# Product Change Note EA-XPR-003

The LPCXpresso LPC1769 board has changed revision to 'rev C' (from 'rev B'). The change was made during October 2013.

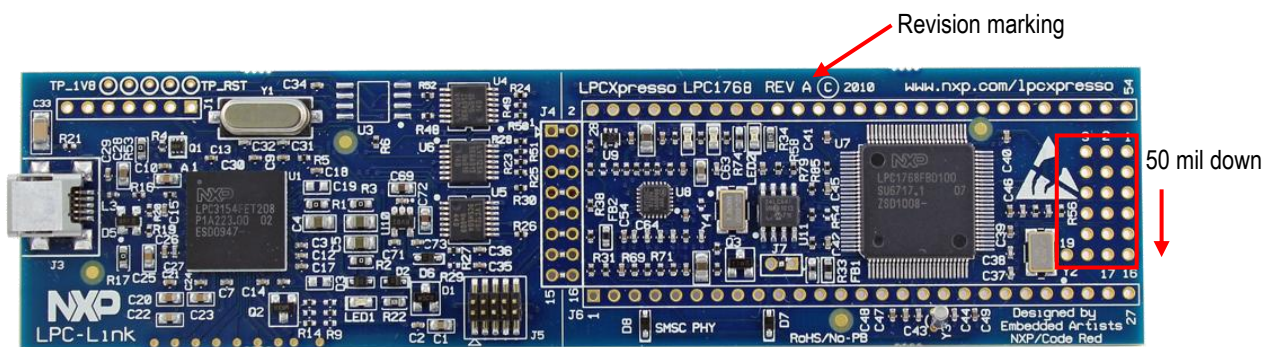
In 'rev C' the 19 holes in the middle-right position of the board (see picture below) have moved 50 mil in the direction of the arrow.
